ADDENDUM No. 3

REQUEST FOR QUOTATION No.: 1220-040-2024-015

TITLE: BEAR CREEK TRACK RENOVATION

ADDENDUM ISSUE DATE: MARCH 14, 2024

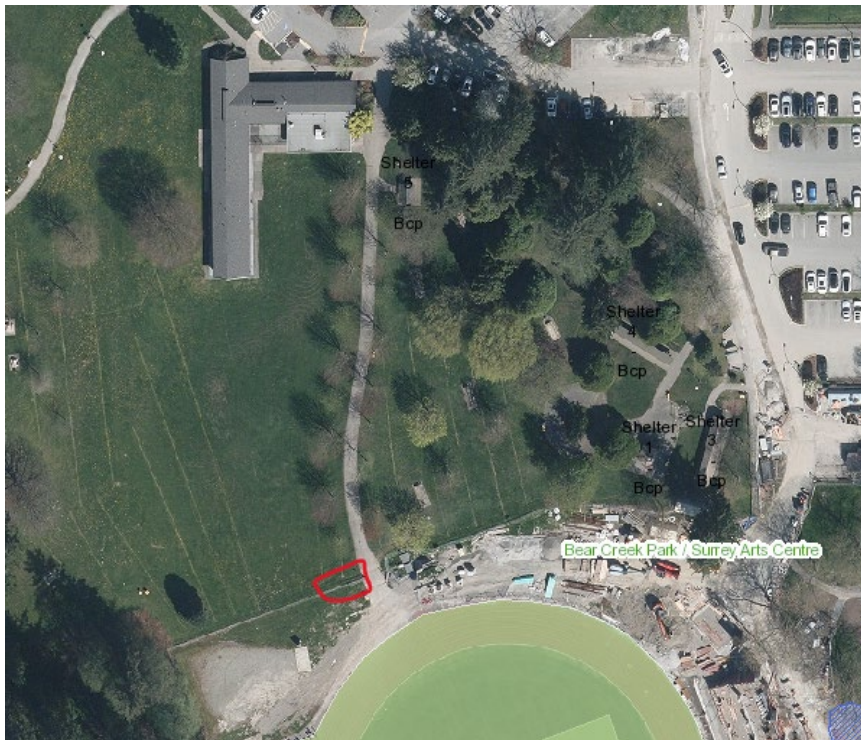
Q14. There are new gates placed at our suggested entrance that are not wide enough for equipment passage for our work. Can we get details of these posts and gates as we will need to remove and reinstall.

A14. The existing entrance posts at north and southwest entrance cannot be removed. It may be possible to take the gates off, but removing the posts will not be possible. The construction access for the site will be as illustrated in the aerial photos with red square.
